Subject: Request for Approval of Class 1 Modification to the Los Alamos National Laboratory (LANL) Hazardous Waste Facility Permit, EPA ID # NM0890010515

Description of the Permit Modification and Proposed Permit
Changes

Class 1 Permit Modification Request

The purpose of this permit modification submittal is to add two structures (124B and 124C) inside of Dome 375. The structures consist of two Klinge Conex refrigeration units that are 480v 3 phase with dimensions for both units collectively of 20-ft long x 8-ft wide x 8.5-ft high. The structures will be co-located adjacent to the roll-up door opening for the modular containment structure (box process area) within Dome 375, which is located on Pad 11, at TA-54, Area G. The doors for each unit will be facing into the box process area. Stainless steel panels, similar to the Permacon will join the two structures and the 375 box process area to integrate the gap between the structures and the roll-up door opening. This will the HEPA filtration capability of the box process area ventilation system. The structures will be fully integrated into the box process area. The two units will be used for the storage of hazardous waste in the f

Attachment G.12 – TA-54 Area G Pad 11 Outdoor Closure Plan

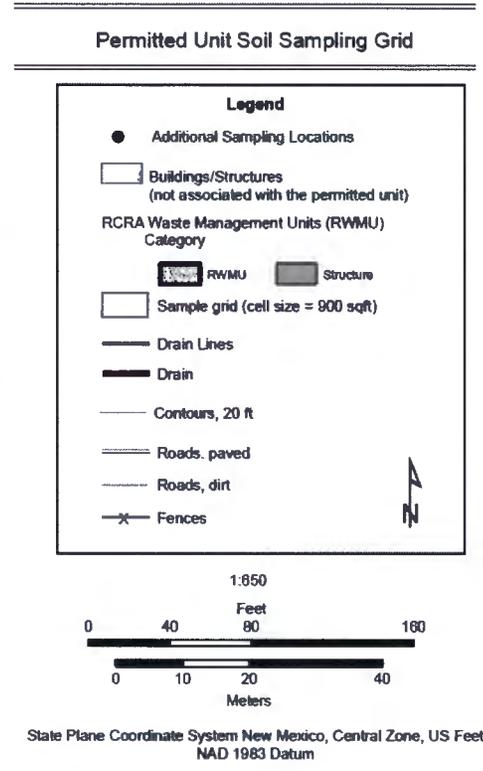
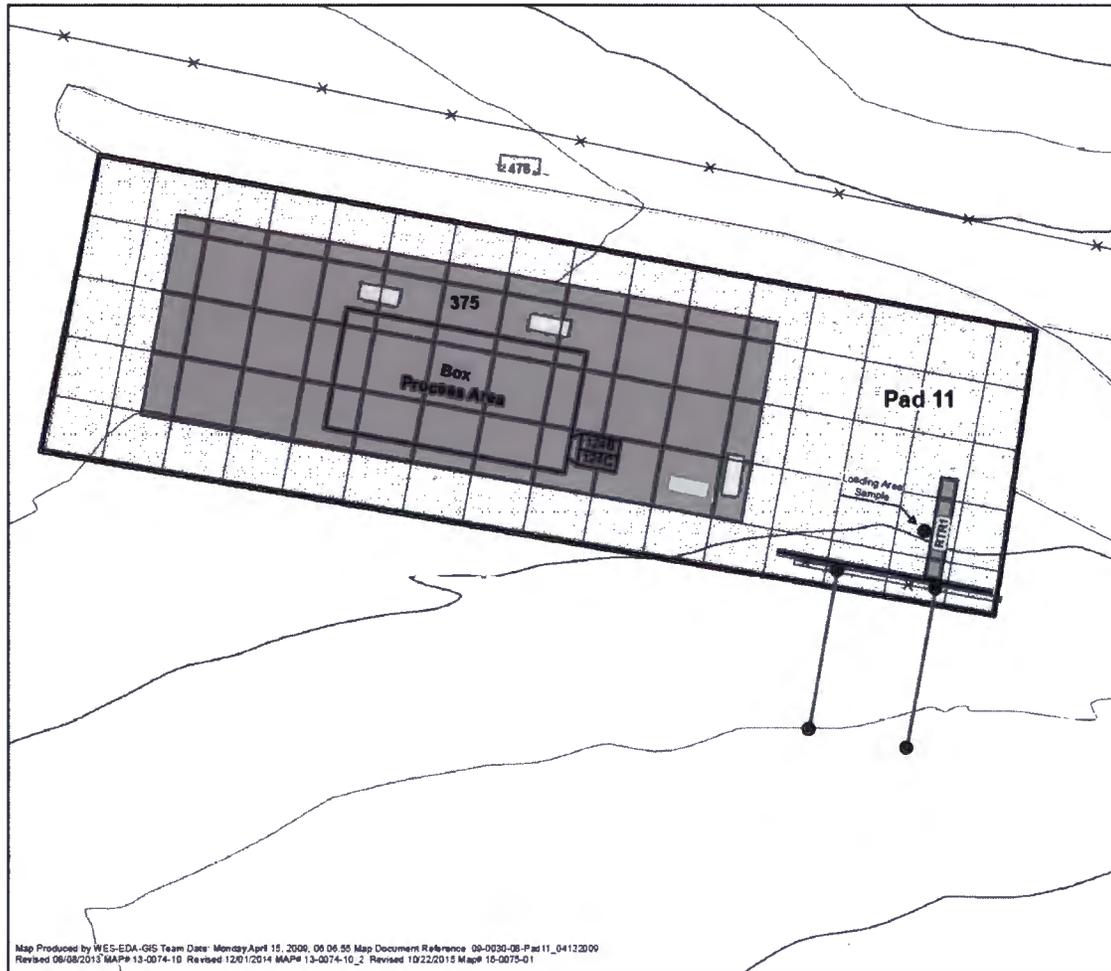
Figure 36, TA-54, Area G, Pad 11 and Figure G.12, *Technical Area 54, Area G, Pad 11 Outdoor Closure Plan*, were revised to include the location of both the Klinge Conex units.
